Access Compliance Report

Public Rights-of-Way

(Curb Ramps)

Intersection ID: 26025	Main Street: CARMEL_RD	Cross Street: CARMEL_COMMONS_BV	Location: SE
ADA ID: 1281CE3E98FA	Ramp Type: Para	Initial Pass/Fail: Fail	Overall Compliance: No
Severity Score: 12.5			
Codes/Mitigation Info/Possible Solution		Field Measurements/Component Compliance

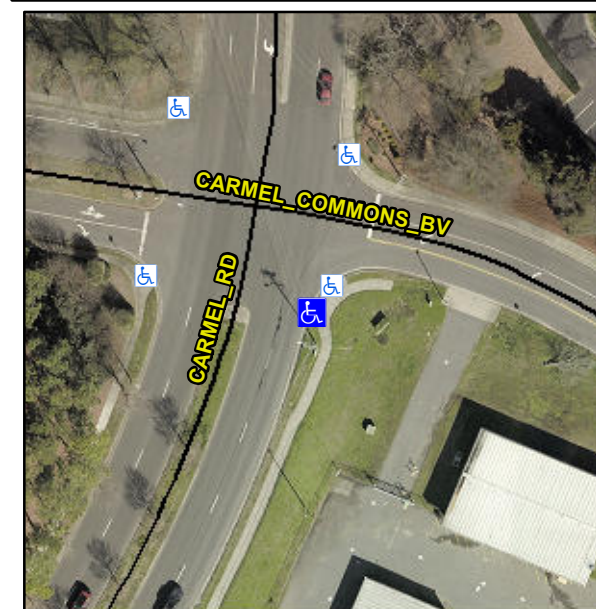
R304.3.2

Compliance	Description	Data	Compliance	Description	Data
N/A	Ramp Length LT (in)	N/A	N/A	Ramp Length RT (in)	43.0
N/A	Ramp Width LT (in)	N/A	Yes	Ramp Width RT (in)	71.0
N/A	Ramp Slope LT (%)	N/A	No	Ramp Slope RT (%)	9.5
N/A	Ramp XSlope LT (%)	N/A	Yes	Ramp XSlope RT (%)	0.7
N/A	Landing Length (in)	N/A	N/A	DWS Provided?	N/A
N/A	Landing Width (in)	N/A	N/A	DWS Contrast?	N/A
N/A	Landing Slope (%)	N/A	N/A	DWS Length (in)	N/A
N/A	Landing X Slope (%)	N/A	N/A	DWS Full Width?	N/A
N/A	Landing Curb? (Y/N)	N/A	N/A	DWS Offset (in)	N/A
N/A	Shared Landing?	N/A			
N/A	Gutter Ponding?	N/A	N/A	Gutter Slope (%)	N/A
N/A	Gutter Lip Ht (in)	N/A	N/A	Gutter X Slope (%)	N/A
N/A	Painted X Walk1?	No	N/A	Painted X Walk2?	N/A
	X Walk 1 Direction	To NW		X Walk 2 Direction	N/A
N/A	X Walk 1 Width (in)	N/A	N/A	X Walk 2 Width (in)	N/A
	X Walk 1 Slope (%)	0.7		X Walk 2 Slope (%)	N/A
	X Walk 1 X Slope (%)	1.6		X Walk 2 X Slope (%)	N/A
N/A	Ramp inside XWalk1?	N/A	N/A	Ramp inside XWalk2?	N/A

Remove & Replace Entire Ramp.
